# RENESAS TECHNICAL UPDATE

Product Category	MPU/MCU		Document No.	TN-RX*-A164A/E	Rev.	1.00
Title	Errata to RX65N Group, RX651 Group User's Manual: Hardware		Information Category	Technical Notification		
Applicable Product	RX65N Group, RX651 Group		Lot No.	Reference Document	RX65N Group, RX651 Group User's Manual: Hardware Rev.1.00 (R01UH0590EJ0100)	
			All

Figure 51.4 Example When the 12-Bit D/A Converter Cannot Capture the 12-Bit A/D Converter Synchronous D/A Conversion Enable Input Signal

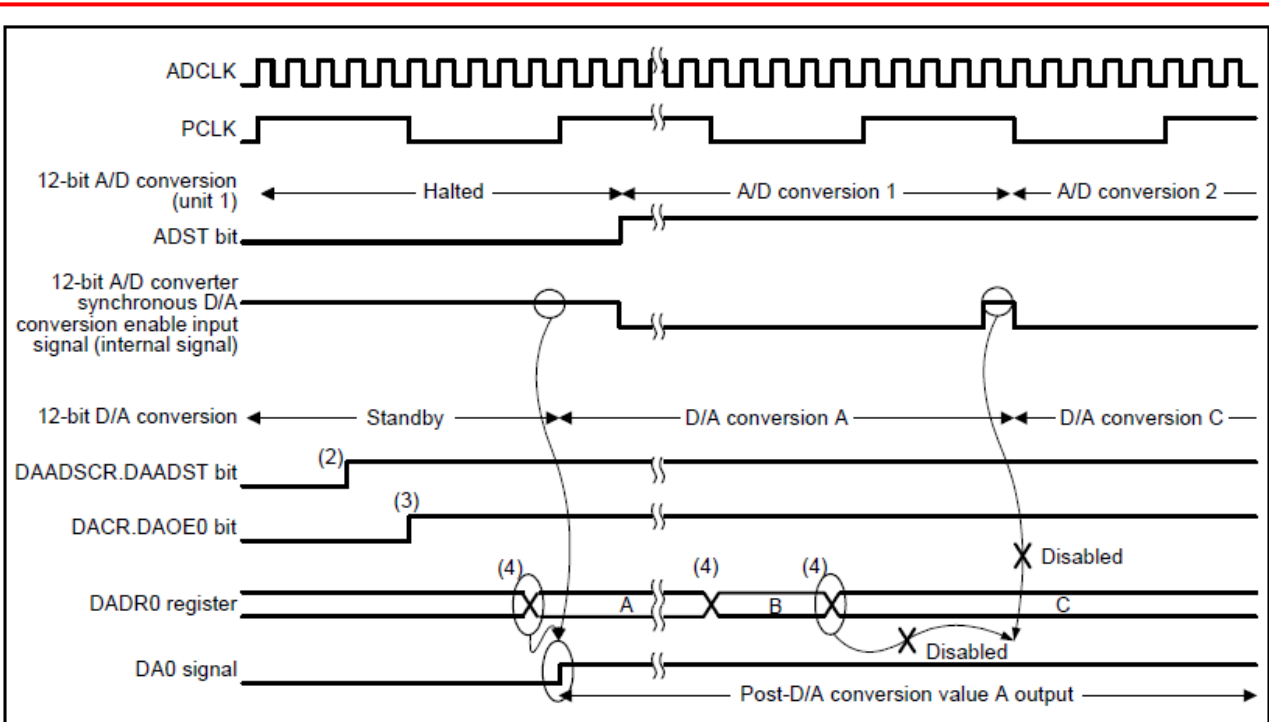
The following description and Figure 51.4 in section 51.3.1 are deleted:

**When ADCLK is faster than PCLK, the 12-bit D/A converter may not be able to capture a 12-bit A/D converter synchronous D/A conversion enable input signal for one ADCLK cycle which is output between A/D conversion 1 and A/D conversion 2.**

Figure 51.4 shows example when the 12-bit D/A converter cannot capture the 12-bit A/D converter synchronous D/A conversion enable input signal. In this case, post-D/A conversion value A is continuously output as the DA0 signal.
